June 1, 2016
Project No. 1948F

**RE: Response to Amended Order of Conditions Review Comments
DEP File No. SE049-0693
200 Theodore Rice Boulevard**

Field Engineering Co., Inc. has received the Request for Amended Order of Conditions review comment letter dated May 27, 2016 prepared by Nitsch Engineering and has prepared the following response narrative and supporting documentation for consideration by the Commission.

| Sheet No. SP-1 | |

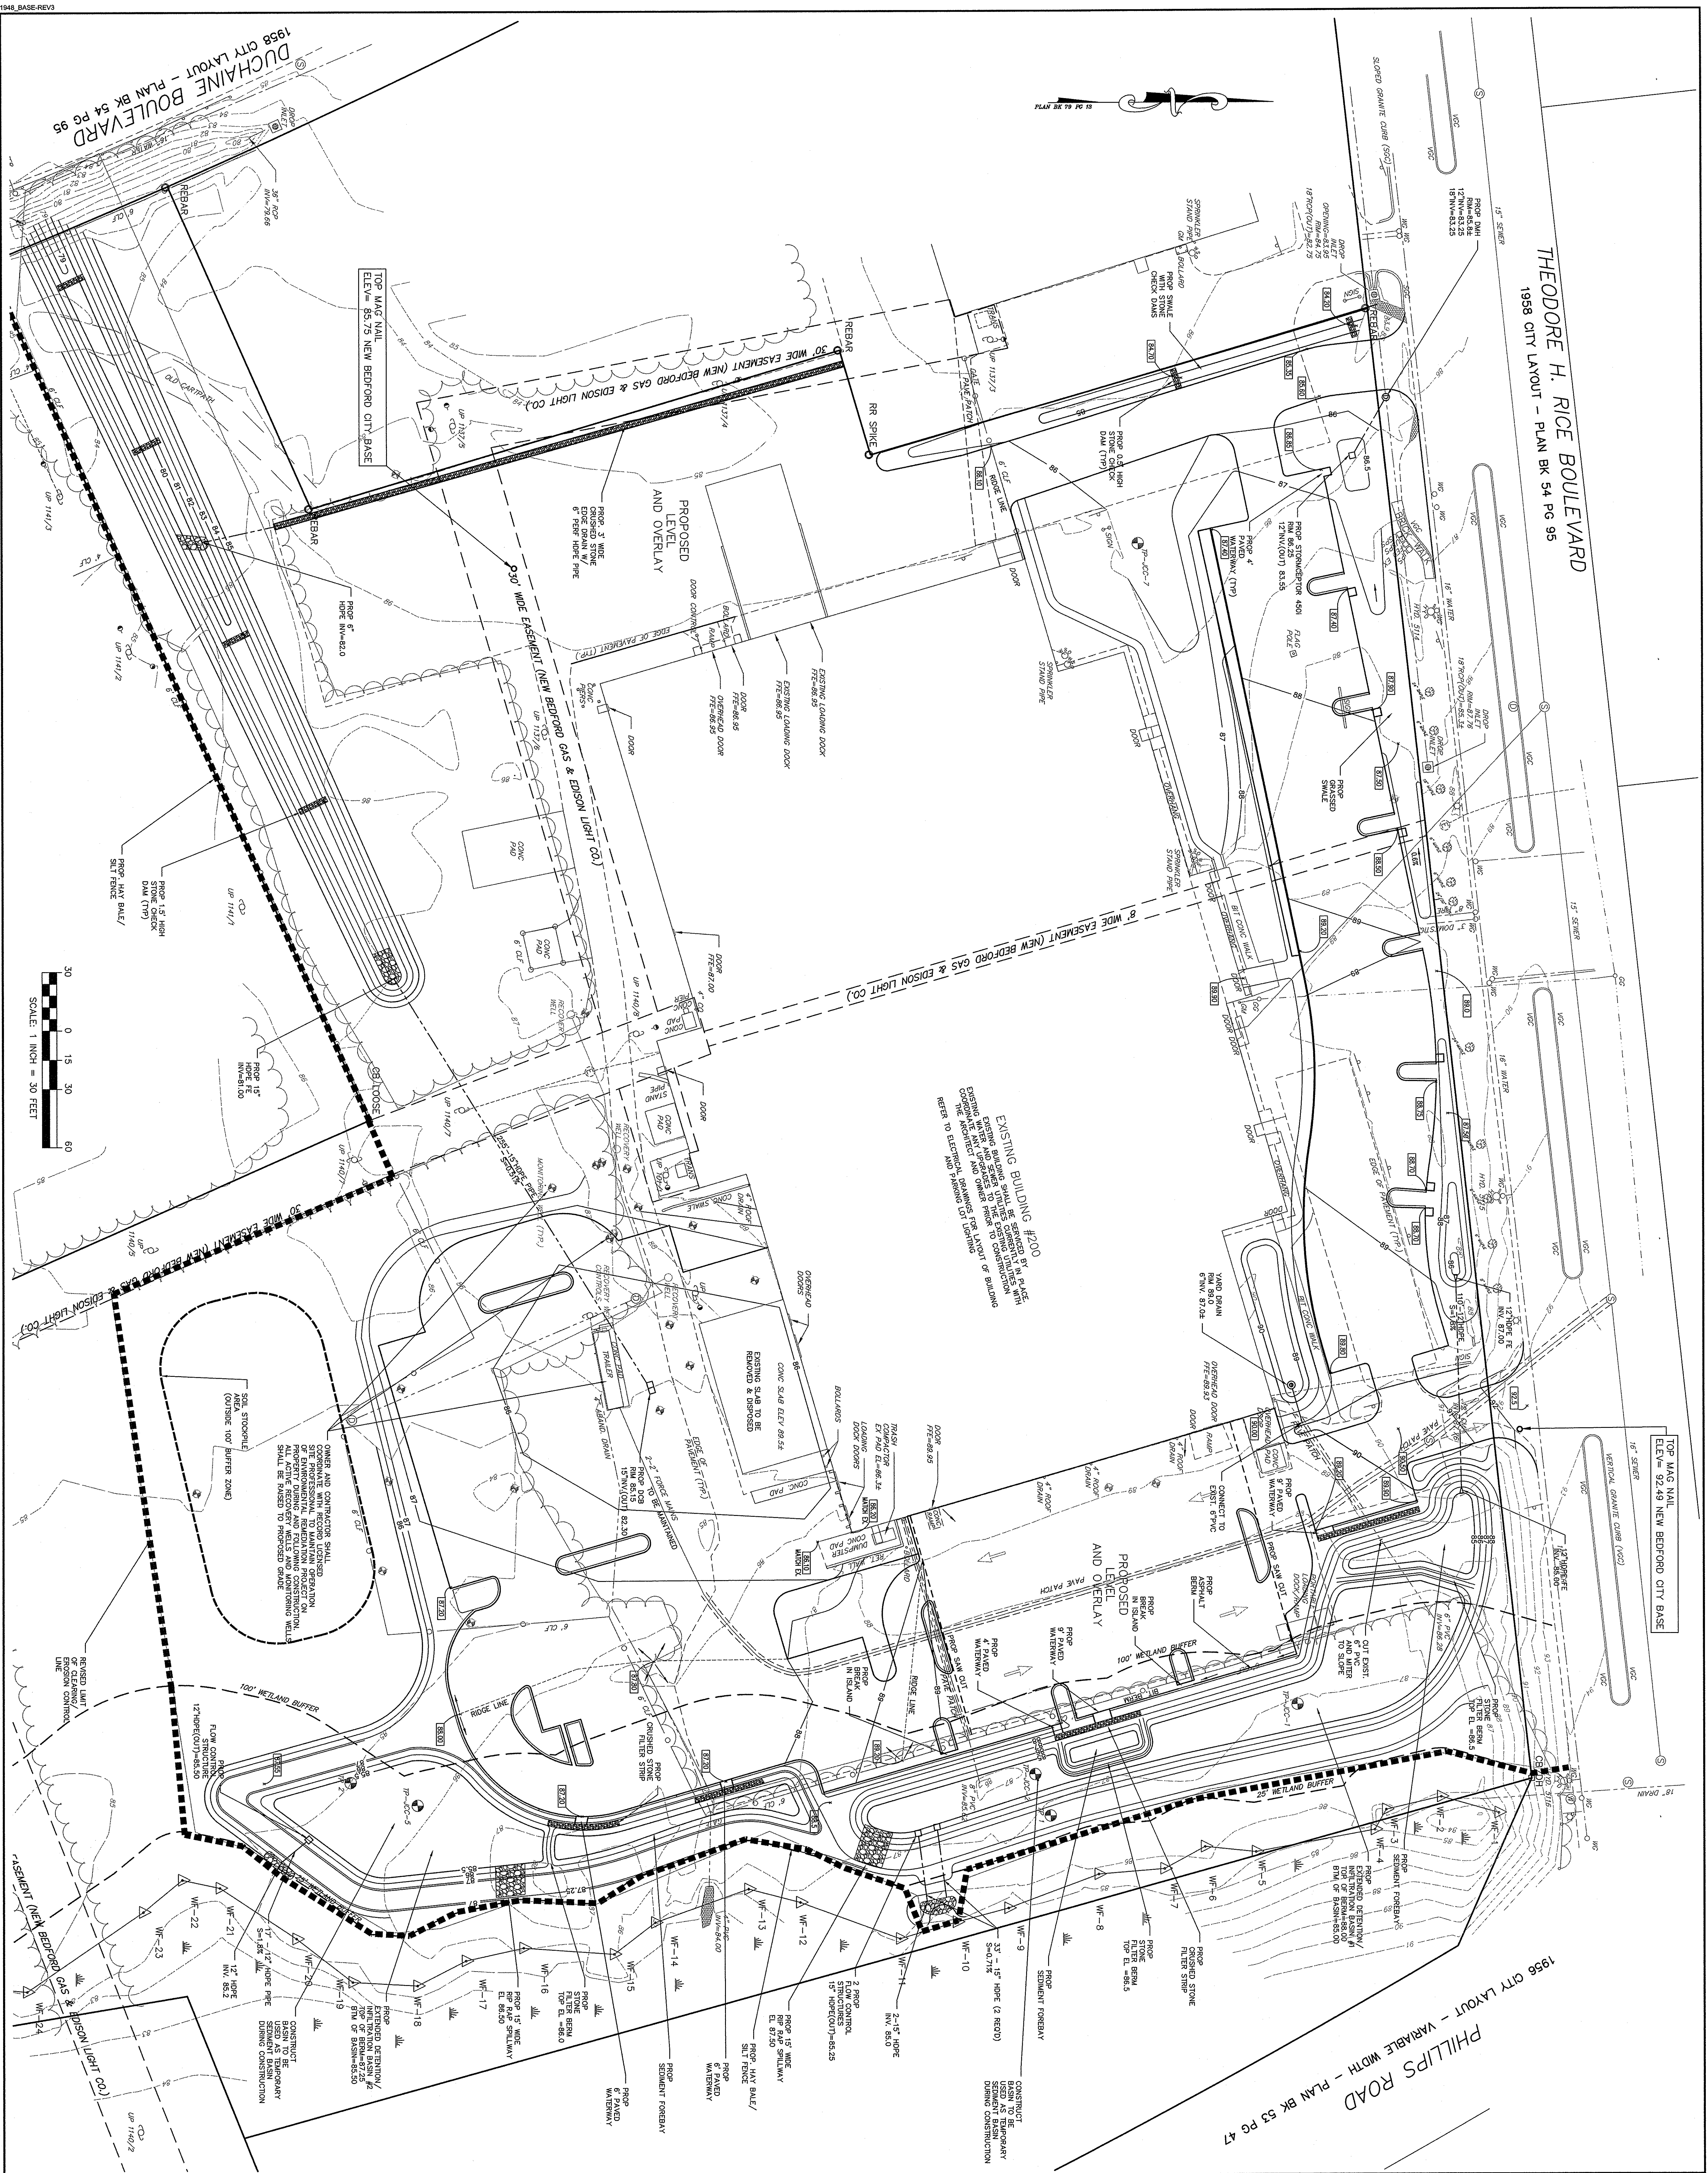
2. The parking lot located in the northwest corner of the site has been revised. Previously, this parking area was designed to drain to a detention basin located directly in front of the building. This detention basin has been removed. The parking lot grading has been changed so the parking lot grades to the north and stormwater either drains towards the landscape island or the newly proposed Stormceptor 450i. The applicant should provide sizing calculations for the stormceptor. This is all new pavement so all stormwater should be treated to remove 80% of Total Suspended Solids (TSS).

3. The curbing in the northern parking lot should be better defined so the stormwater flow paths are apparent. As drawn on the submitted plans, it appears that curb is not proposed along the northern edge of the parking lot. Therefore, as drawn, stormwater will flow into the landscape island on the western side of the parking lot and bypass the proposed stormceptor unit. If curb is installed, the grading will need to be revised to allow stormwater to flow around the parking islands. The grading and design of this area should be revised so that water flows to the stormceptor, consistent with the drainage calculations.

4. The driveway on the western side of the site was approved to drain into a landscape depression that would function as a sediment basin or forebay. There was a pipe that allowed water to flow to the site's closed drainage system and receive additional treatment. The revised design contains a depression only. The depression is less than one foot deep. There is no outlet pipe, so presumably this area is intended to either infiltrate into the ground or water will overtop during large storms. Calculations regarding the design of this area were not developed so it is unclear whether this depression can accommodate stormwater generated by the driveway up to the 100-year storm.

5. The existing parking lot located to the west of the existing building was previously designed with more formal parking, landscaped islands, and a closed drainage system providing water quality treatment. The revised plans show this area to be scarified and new pavement installed. There is no reduction in impervious surface or any stormwater best management practices. Therefore, there are no water quality improvements associated with this area under the new design. During the site walk, we discussed the options for providing water quality treatment in the re-paved area. We recommend water quality Best Management Practices be incorporated into this area.

6. Landscape islands have been added to the parking lot located to the east of the building. These islands could restrict the movement of water to the paved waterway that discharges to basin 1. The revised design implies that curbing will not be installed at the edge of the parking area, which would create a situation where water flows directly into the basin as opposed to the forebay as originally designed. Curbing and/or grading revisions should be developed to insure that water is directed to the paved waterway and into the sediment forebay.

7. We recommend the applicant check the parking lot grading located near the southeast corner of the building. The proposed grading implies a low point that may create ponding.

8. The applicant should confirm the size of the pipe leading from the proposed double catch basin located in the parking area south of the building.

RESPONSE: Sizing calculations for the Stormceptor 450i are included as an Attachment to this Response Letter. As the attached calculations show, the Stormceptor 450i will provide more than 80% removal of Total Suspended Solids as recommended by your consultant.

RESPONSE: We have relocated the proposed Stormceptor into a grassed swale within the landscaped area between the parking lot and Theodore Rice Boulevard and have proposed paved waterways at each landscape island to ensure that the water flows into the swale and ultimately into the Stormceptor.

RESPONSE: The design of the westerly driveway has been revised to flow into a grassed swale that will overtop towards the existing drop inlet located along Theodore Rice Boulevard. The existing paved parking area currently flows into the existing drop inlet and there will be overall reduction in the amount of pavement that will flow directly to the drop inlet with the addition of the grassed island. No attenuation was assumed or included in the hydrologic calculations from this swale.

RESPONSE: To address your consultant's concerns, we are proposing to remove a strip of pavement along the western side of this parking area and will replace with a 3' wide crushed stone edge drain. This edge drain will be equipped with a 6" perforated HDPE pipe which will discharge flow to the proposed swale as shown on the Revised Plan.

RESPONSE: The Revised Plans shown asphalt berm along the easterly perimeter of this parking lot and the level/overlay will be graded to direct runoff towards the proposed paved waterways into the sediment forebay. Notations are provided on the plans to break the berm around the proposed landscape islands to ensure a direct flow path to the paved waterways.

RESPONSE: Additional existing and proposed spot grades and contour revisions are shown on the Revised Plan to clarify the grading in this area.

RESPONSE: We have reviewed the sizing of the pipe from the proposed double catch basin south of the building. Following review of the calculations, we have increased the size of this pipe to 15" to ensure that this pipe can convey up to the 25 year storm to the swale. The Revised Plan illustrates this change and pipe sizing calculations have been provided as an Attachment to this Letter.
